From: Guoda Vaitkeviciute [REDACTED]
Sent: 25 July 2025 16:39
To: Emy Circuit; Sophie Morris
Cc: Tom Pike; Jean Mulovi; Kane White; Connor Corrigan
Subject: SWDR - Conditions 12, 13 and 15 (Application Reference: 250213) and 5 and 6 (Application Reference: 242838)
Attachments: WMHP-TG-SRWG1-SK-DD-0594-P01 - DITCH PROFILES.pdf; 4977_Response to Consultee Comments 5 and 6_v1.2_20.06.2025.pdf; 4977_LAN_XX_XX_RP_L_1000 Written Landscape Specification P04 - Tracked.pdf; 4977_LAN_XX_XX_RP_L_1000 Written Landscape Specification P04.pdf; 4977_LAN_XX_XX_RP_L_1001_Landscape Management Plan P05 - Tracked.pdf; 4977_LAN_XX_XX_RP_L_1001_Landscape Management Plan P05.pdf; 4977_SWDR_Biodiversity Net Gain Report (tracked changes)_BW_V4-0.pdf; 4977_SWDR_Biodiversity Net Gain Report_BW_V4-0.pdf; 2025_07_22 EA responseconds 5_6.pdf; Environment Agency response 2025_07_04 conditions 12, 13 & 15 250213.pdf

Please find attached the Applicant's responses to the comments received from the Council's Landscape Officer and the Environment Agency (attached for reference) in respect of Conditions 12, 13, and 15 (application reference: 250213).

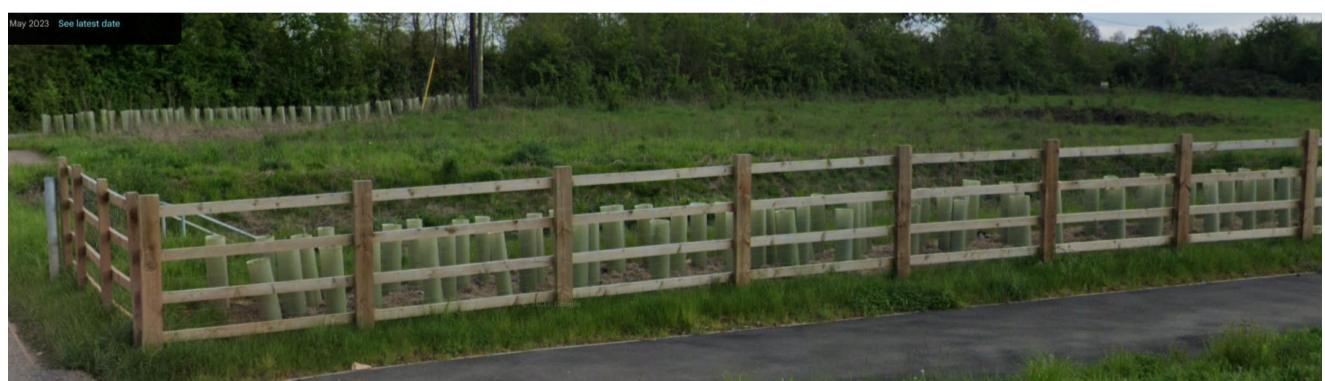
2.5	<p>Although in 6.3.112 and 6.3.113, the height and width of the berms and the slope, and monitoring at different times of year, is mentioned, there is no mention of expected water levels at each time of year. Nor is there any mention of cross sections for these berms. Additionally, the berms are very uniform all the way along. There should be variation in berm height and slope along the length of the channel.</p>	<p>Refer to drawing WMHP-TG-SRWG1-SK-DD-0594 submitted under Discharge of Condition 5 (Application Reference: 242838). This drawing is attached with this response for reference.</p> <p>The water level within the diverted Luckley Brook channel is expected to vary seasonally, ranging from dry conditions to full submergence of the channel. While we understand the ecological benefits of introducing variation in bench levels, this is not being considered as part of the current design. The principle of the channel remains on maintaining consistent conveyance and hydraulic performance within the channel, in consistency with the full planning application (reference: 192928). It is also understood this variation will generate naturally over time through the deposition of sediment.</p> <p>A similar arrangement has been approved and implemented at Eastern Gateway, Waterloo Road, Wokingham (upstream of the Emm Brook), which shows fast establishment of wildflowers that contribute to creation of variation in the ditch profile from the engineered design:</p> <p>Image 1: May 2023, showing where the headwall guardrails are clearly visible.</p>  <p>Image 2: August 2023, showing established wildflowers and headwall guardrails hidden:</p>

Image 3: August 2023, showing established ditch vegetation in short period of time giving variation to profile:
